Inspection/Service Report

Anonymized inspection example
Client and property details withheld

Report:	Inspection/Service Report
Inspection Date:	
Inspection Type:	Level II Inspection
Customer:	
Property:	
Systems Inspected:	5
Photos Included:	453
Deficiencies Noted:	Yes
Minimum Standards Met:	No
Suitable for Continued Use:	No

1.14. Primary Bedroom Fireplace – Factory-Built Chimney/Vent in Adjoining Areas – Deficiencies Noted

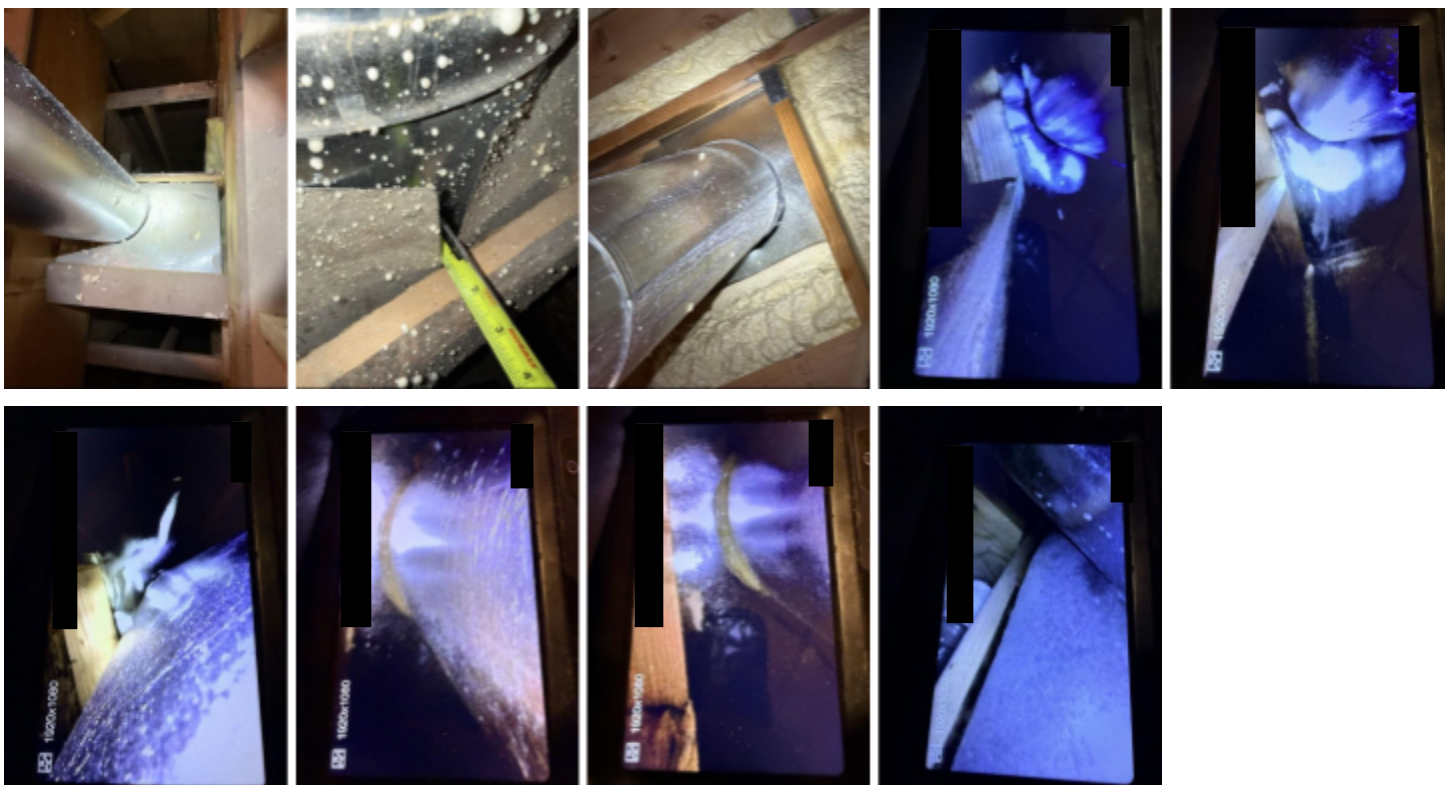
Description/Notes: Required vent clearances are not maintained in the accessible attic area. A loose 2x6 framing member is in contact with the vent, and spray-foam insulation is adhered to portions of the vent along the accessible run.

Deficiencies noted: Clearances Not Met.

1.16. Primary Bedroom Fireplace – Fireblocking – **Deficiencies Noted**

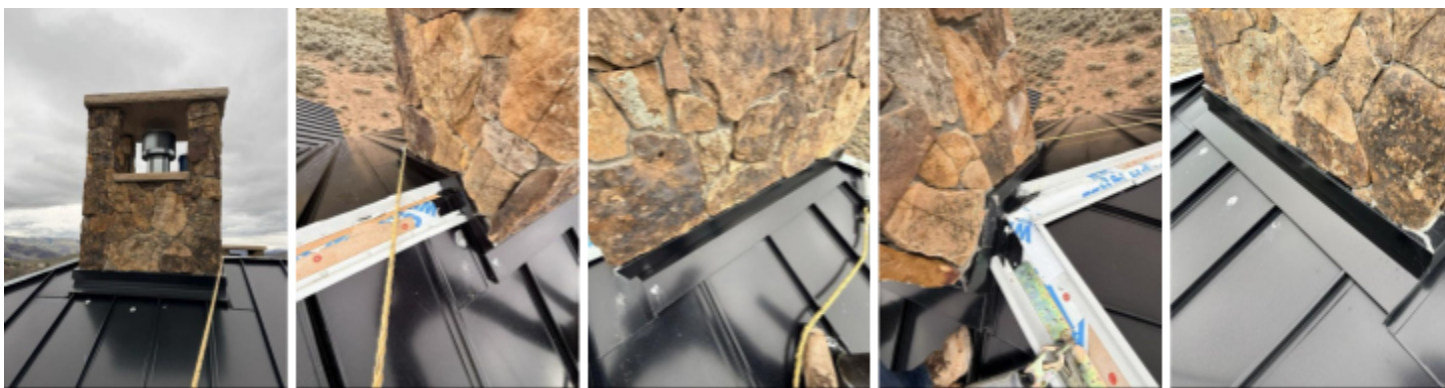
Description/Notes: Fire blocking is incomplete and the Chase is open into the attic.

Deficiencies noted: Component/materials Missing, Improperly Constructed/supported.

1.18. Primary Bedroom Fireplace – Factory-Built Chimney/Vent Termination – **Deficiencies Noted**

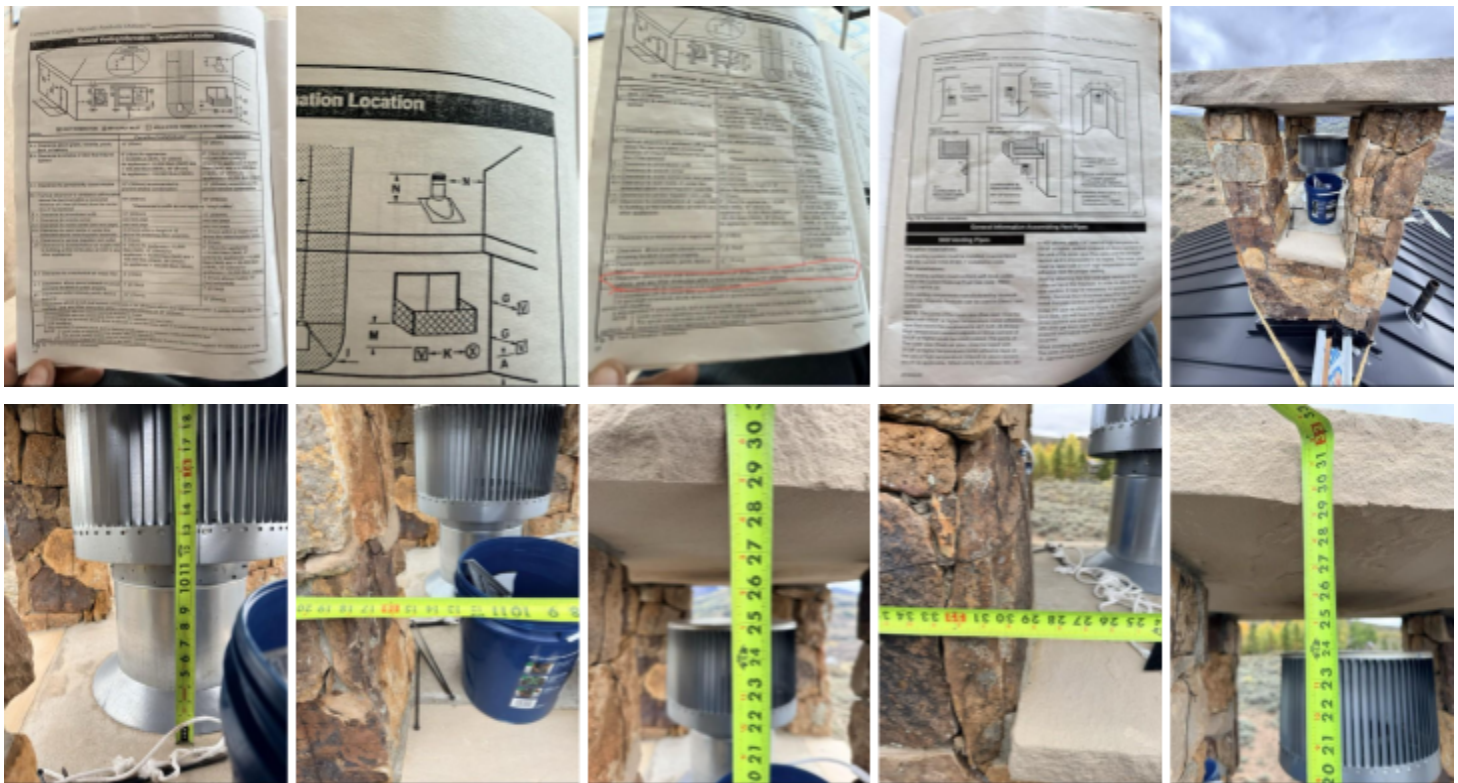
Description/Notes: The DVT44 installation instructions require the vertical termination to extend a minimum of 24 inches above the highest point where the vent penetrates the roof. The existing termination height does not meet that requirement. The manufacturer also identifies specific listed components for terminating the vent at or through a chase; any corrected termination should use a documented listed/approved DVT44/SK8 configuration.

Deficiencies noted: Height Requirements Not Met.

1.19. Primary Bedroom Fireplace – Shrouds – **Deficiencies Noted**

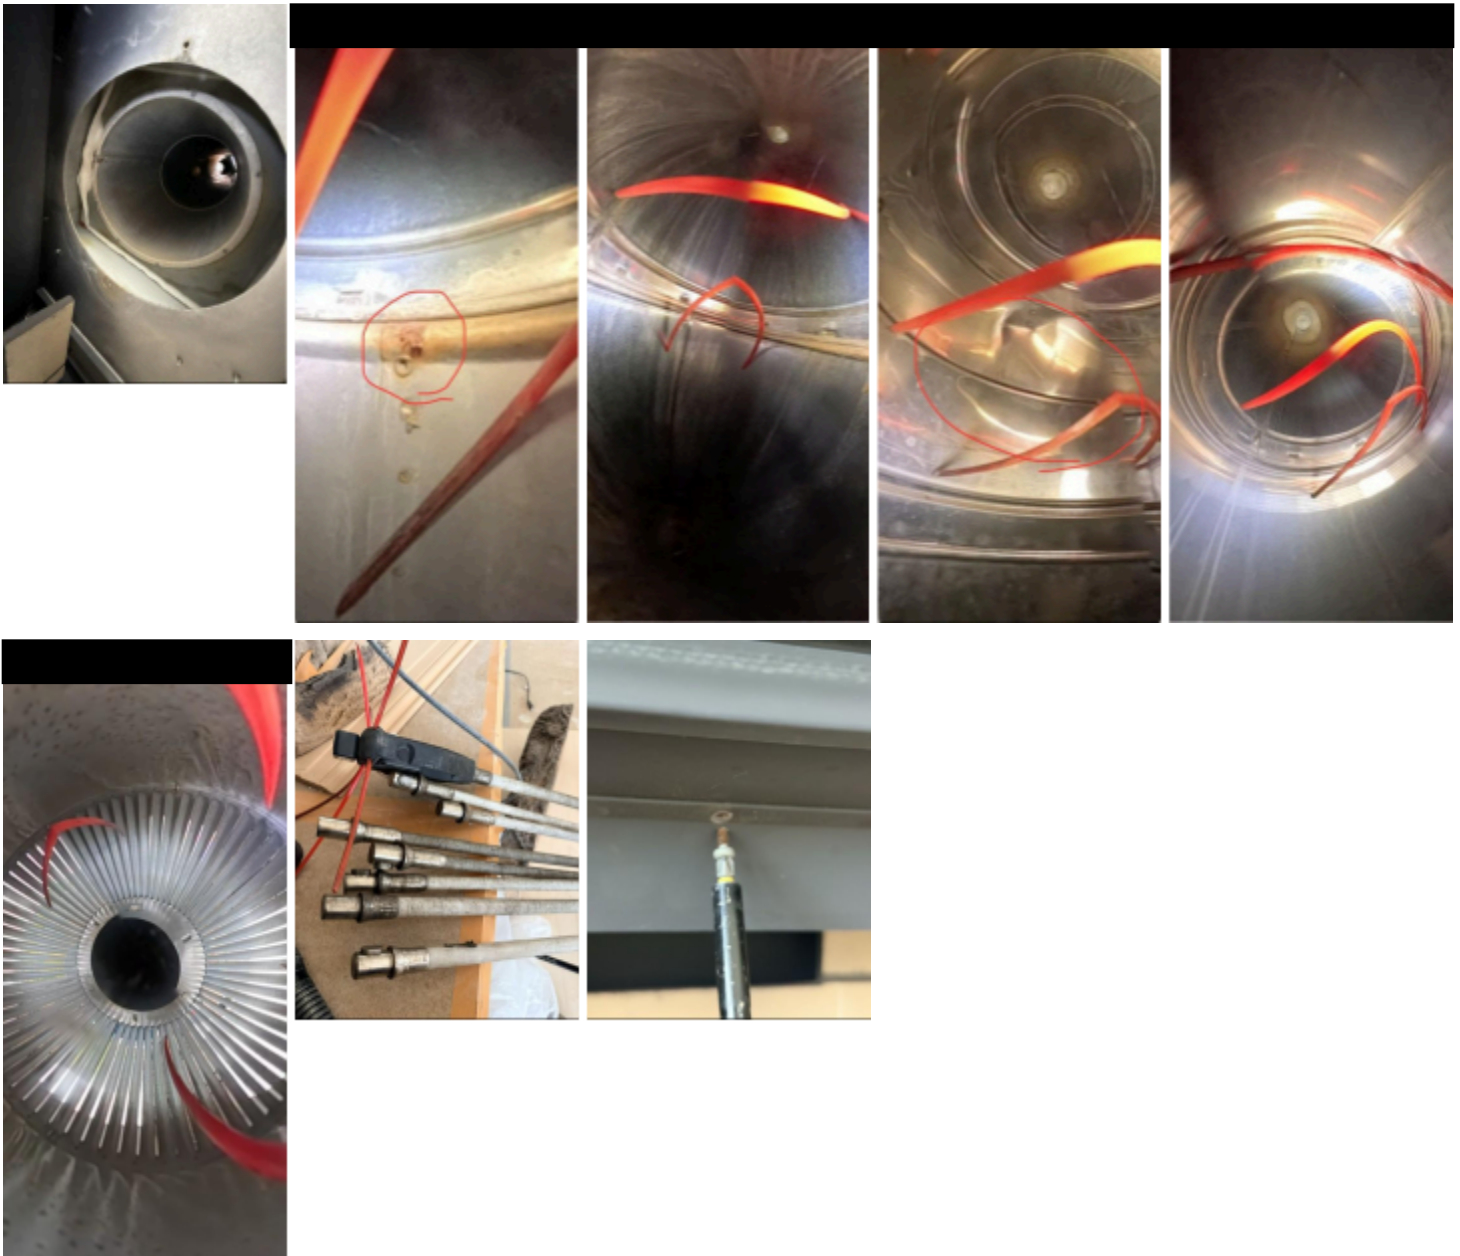
Description/Notes: The existing vent termination is located within a field-built stone enclosure. The DVT44 instructions provide specific listed SK8 chase-top termination components, including an extended round-top termination and dedicated chase-top housings. The existing field-built configuration does not match one of the documented listed chase-top arrangements.

Deficiencies noted: Existing field-built termination enclosure is not a documented listed/approved termination configuration.

2.17. Primary Bathroom Fireplace – Factory-Built Chimney/Vent Termination – **Deficiencies Noted**

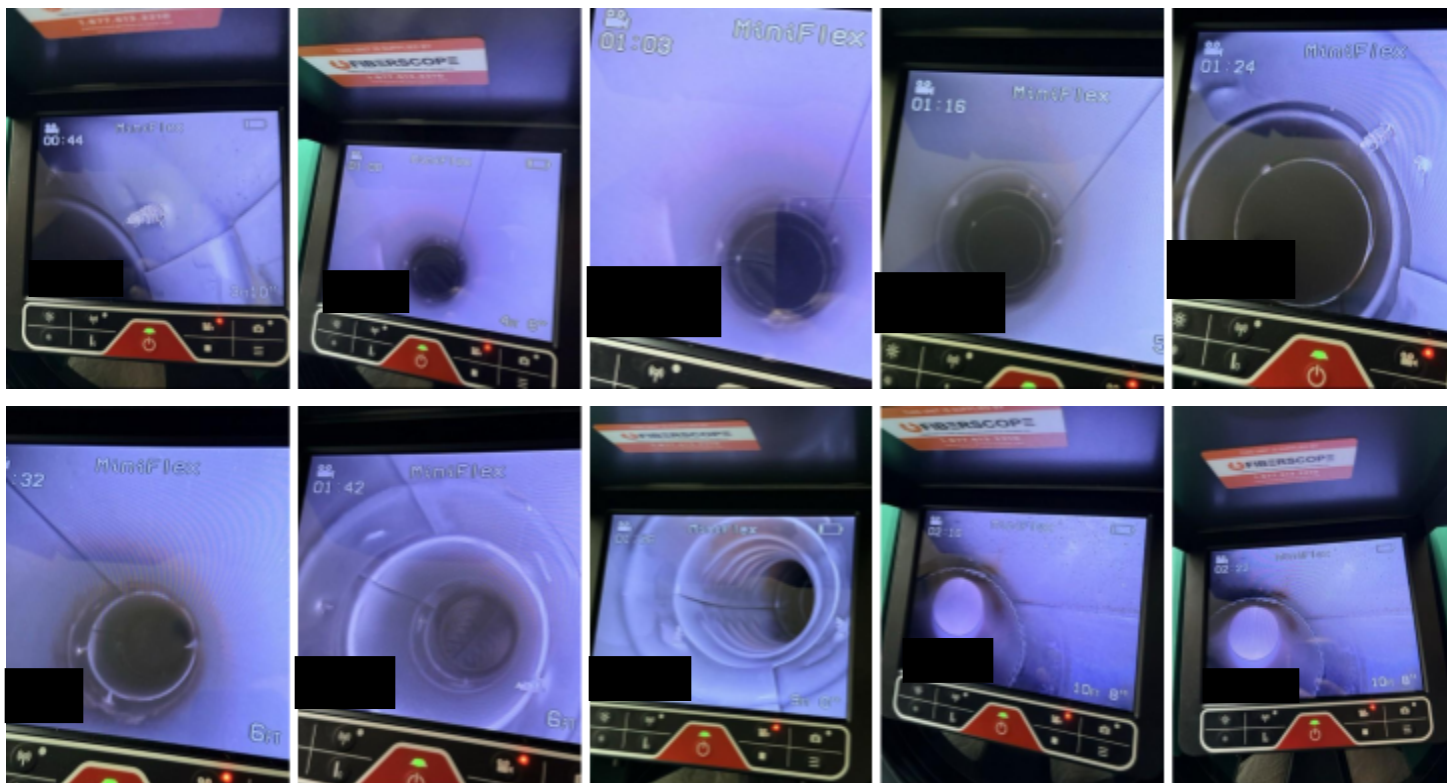
Description/Notes: The exterior termination does not have the required unobstructed area in front of the termination hood. The manufacturer requires a minimum 24-inch clearance in front of the termination. The existing architectural projection is located within that required clear space.

Deficiencies noted: Termination Clearances Not Met.

3.7. Main Level Great Room Fireplace – Firebox and Internal Components – Deficiencies Noted

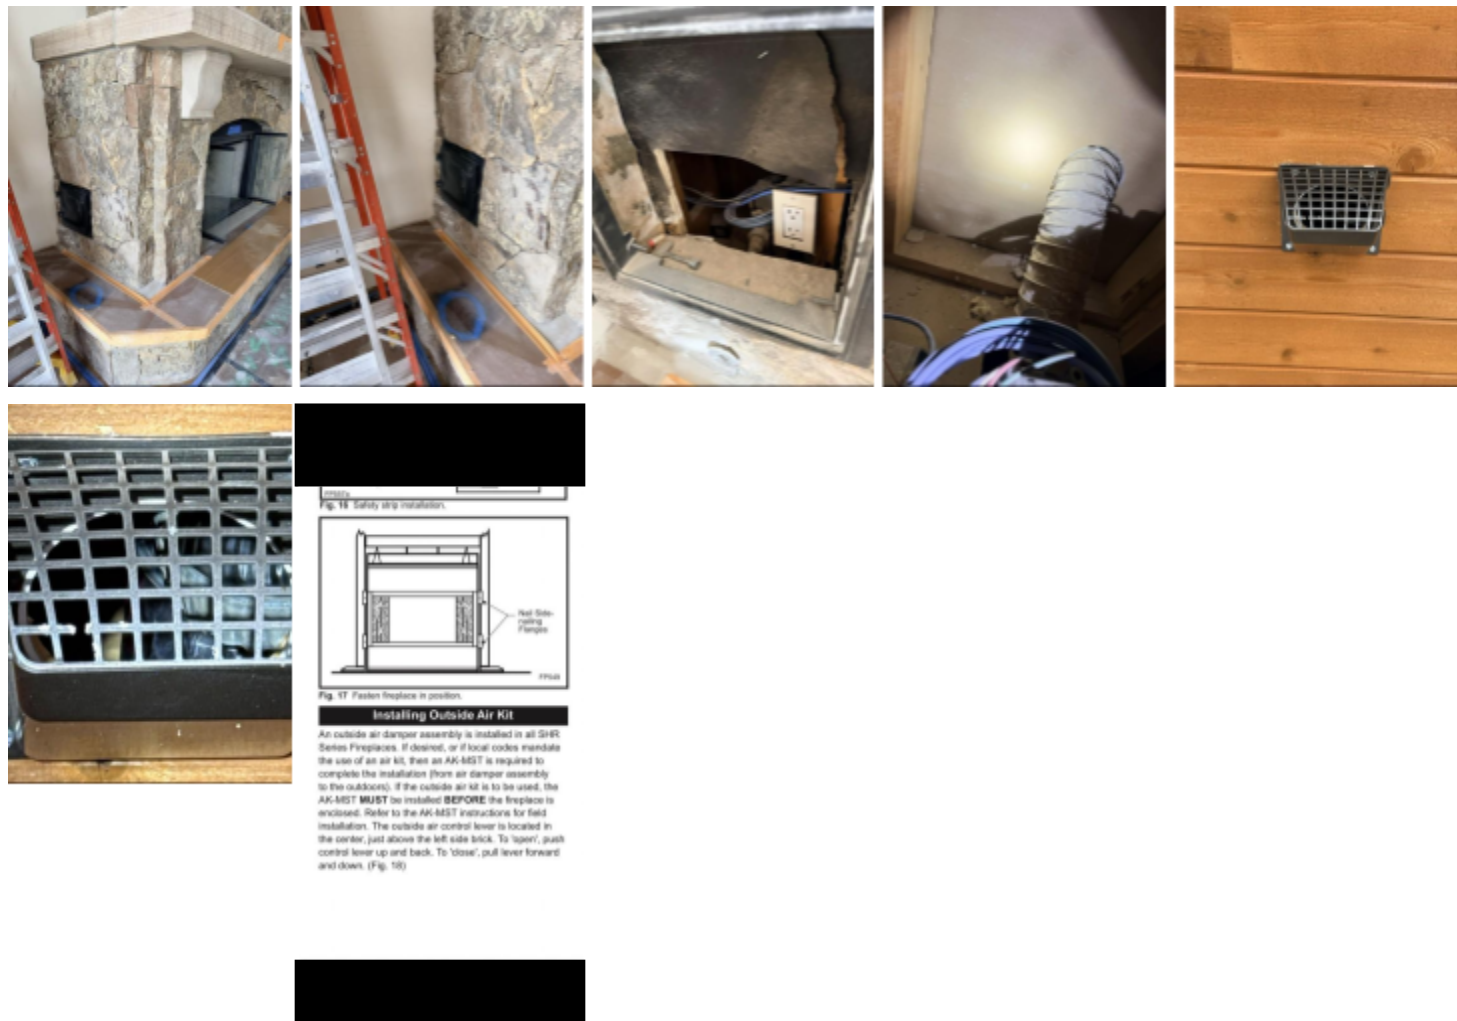
Description/Notes: Rear and hearth/base refractory panels are cracked and broken.

Deficiencies noted: Damaged/deteriorated, Refractory/brick Issues.

4.20. Main Level Hearth Room – Factory-Built Chimney/Vent Termination – **Deficiencies Noted**

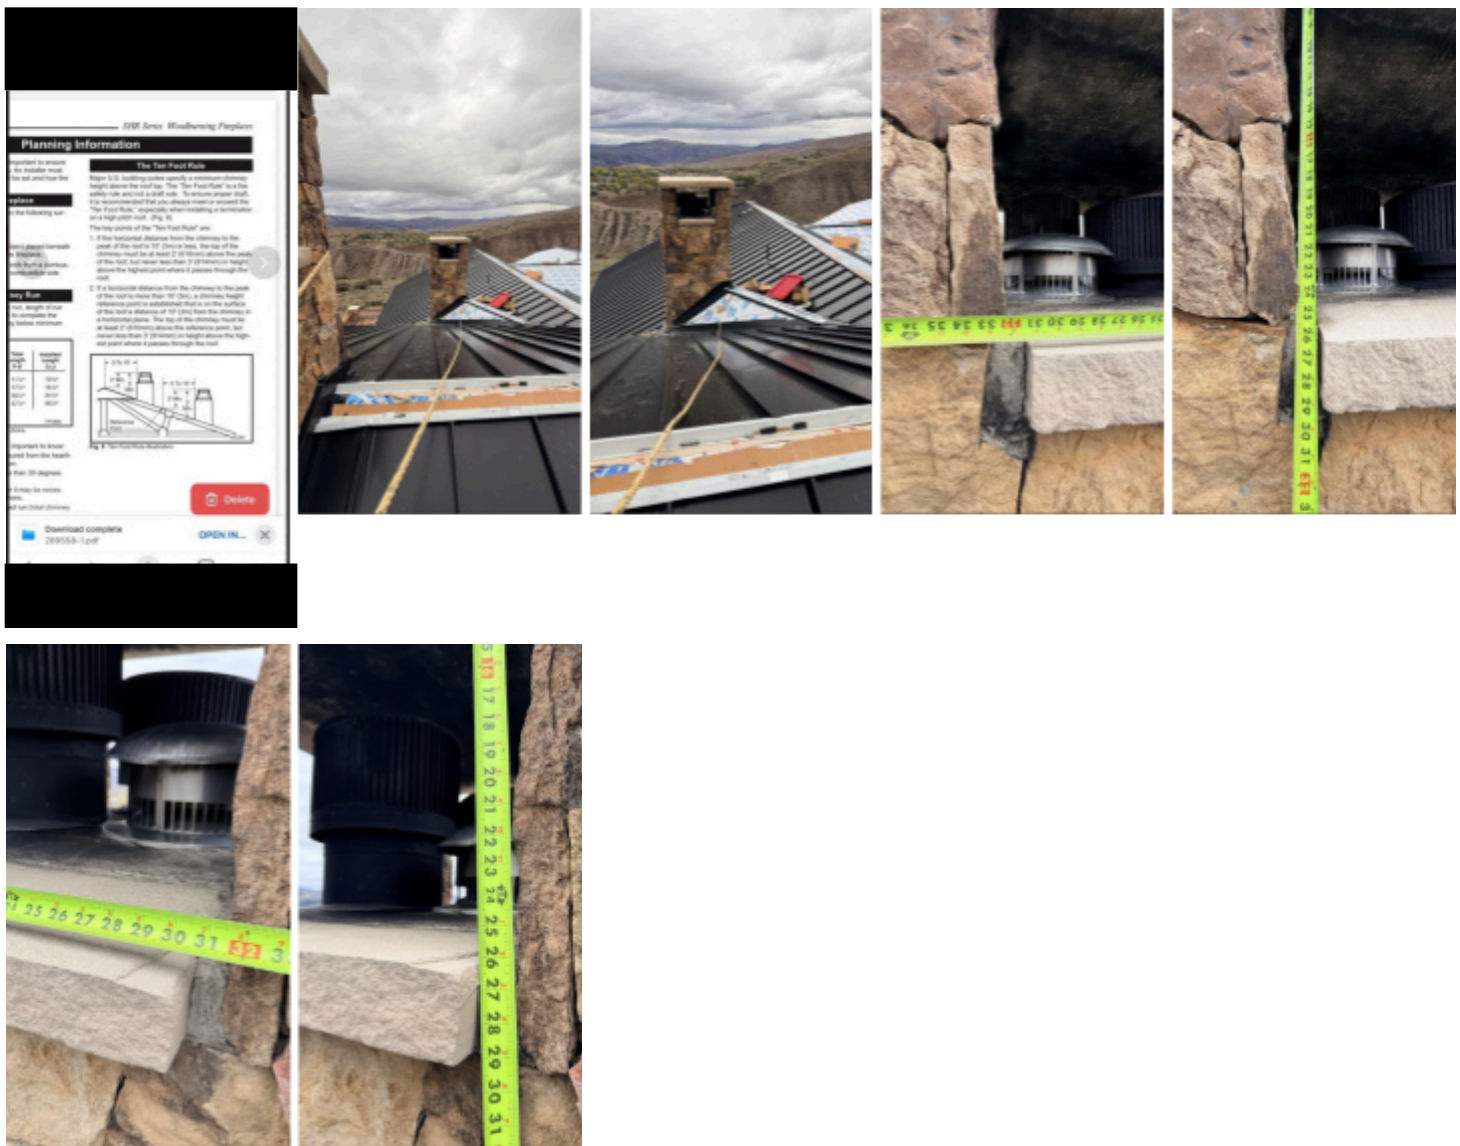
Description/Notes: The Type 11CF chimney satisfies the applicable overall minimum termination height above the roof and the manufacturer's Ten Foot Rule based on field measurements. This termination shares the same field-built stone chase/enclosure with other chimney/vent terminations. The manufacturer's termination instructions require chimney tops within one enclosure to be spaced a minimum of 21 inches on center. The observed spacing between the terminations is less than the required 21-inch minimum; an exact center-to-center dimension was not obtained during the inspection.

The manufacturer permits the RLTCF11L extended chase termination where the intermediate 11CF chimney section terminates no more than 12 inches below the top of the flashing collar. The flashing collar itself is required to extend a minimum of 2 inches above the enclosure top. Portions of this connection are concealed by the existing stone crown/enclosure and these dimensions could not be fully verified.

5.3. Lower Level Family Room – Arrival Test Fire – Deficiencies Noted

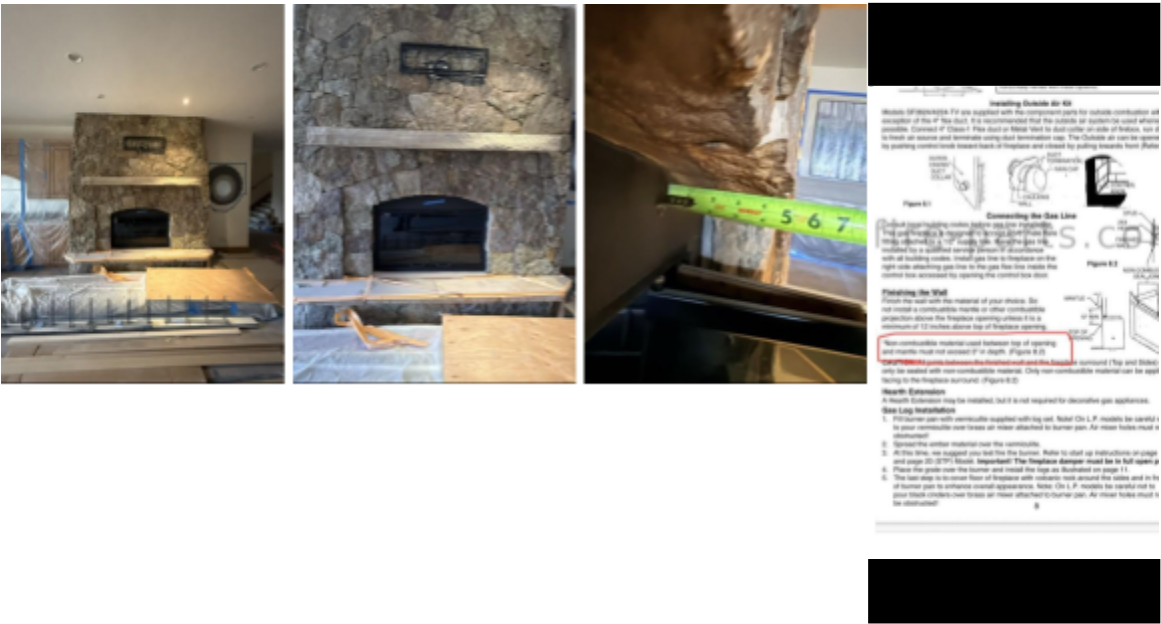
Description/Notes: Unit cannot be tested as there was no gas. The key valve was turned on, but it did not allow gas to flow to the valve and pilot assembly. I turned the key valve back off before leaving.

Deficiencies noted: Did not test fire.
